RIVERDALE CITY PLANNING COMMISSION AGENDA CIVIC CENTER - 4600 S. WEBER RIVER DR. TUESDAY – MARCH 14, 2023

- Consideration of recommendation to City Council regarding Final Subdivision and Site Plan request for Coleman Vu Heights PRUD Subdivision and Site Plan located at approximately 5368 South 1050 West, as requested by Goldcrest Homes/RD Development Group.

Plan Review For Coleman VU Estates

GRADING AND DRAINAGE PLAN

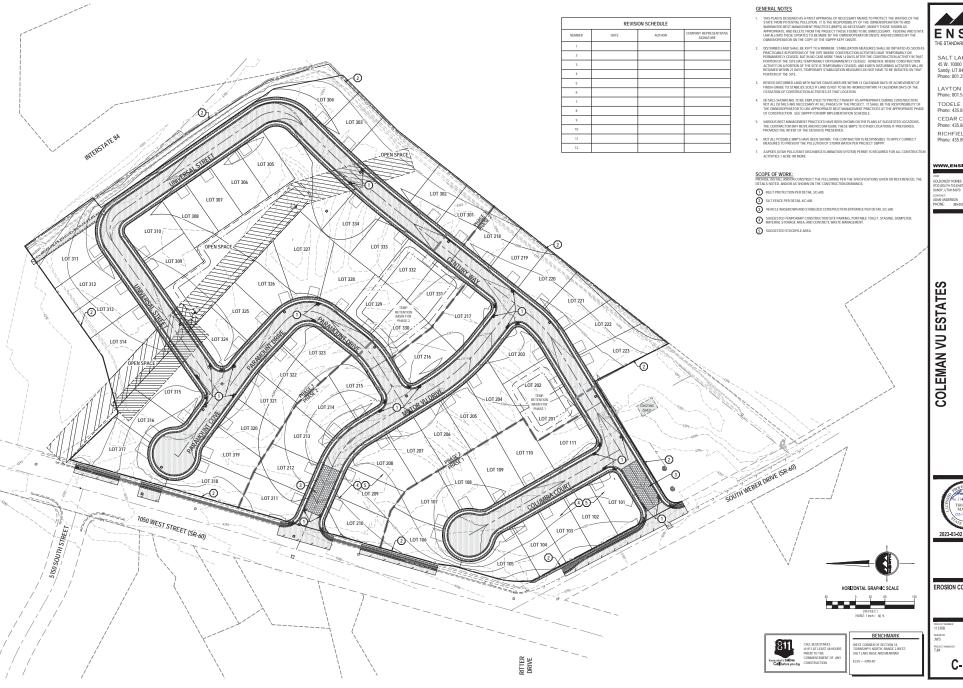
- 1. Because the detention basin has the potential to be over 30" deep with water, it must be fenced.
- 2. Provide a "Storm Water Maintenance Schedule" and a "Maintenance Plan".
- 3. The temporary retention basins need to have emergency spillway identified to ensure no flooding on adjacent properties.

EROSION CONTROL PLAN

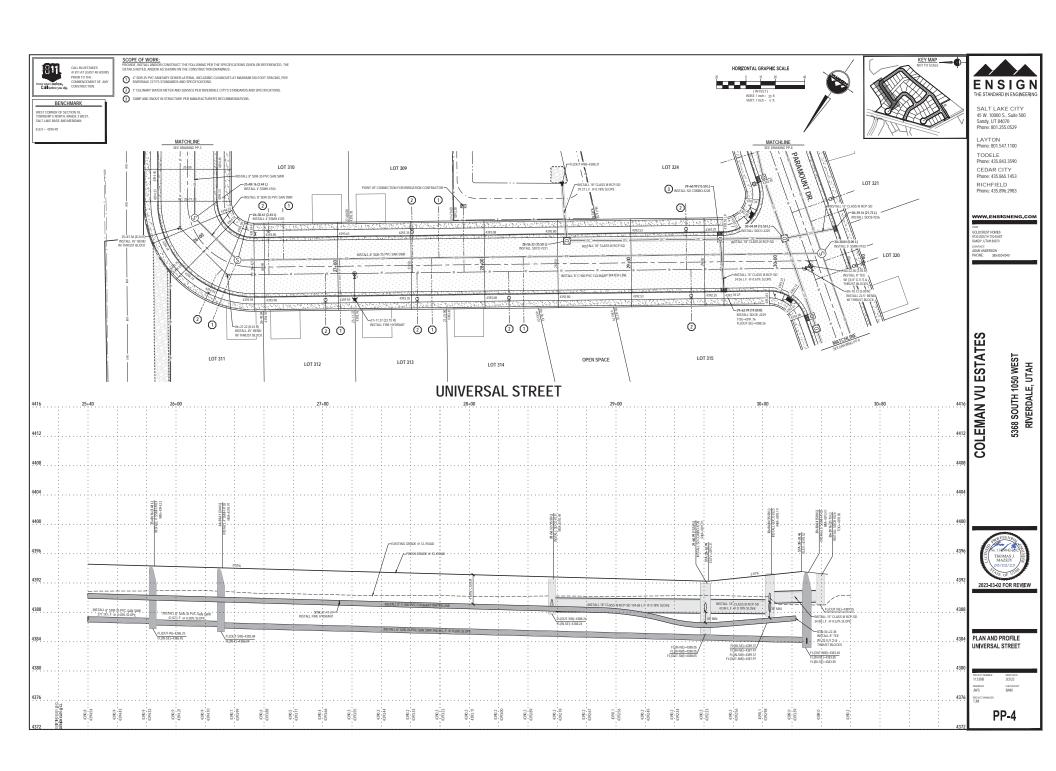
- 1. The plans need to be updated to reflect the multiple phase projection for the site.
- 2. "Vehicle washdown and stabilized construction entrances" need to be identified for the different phases.
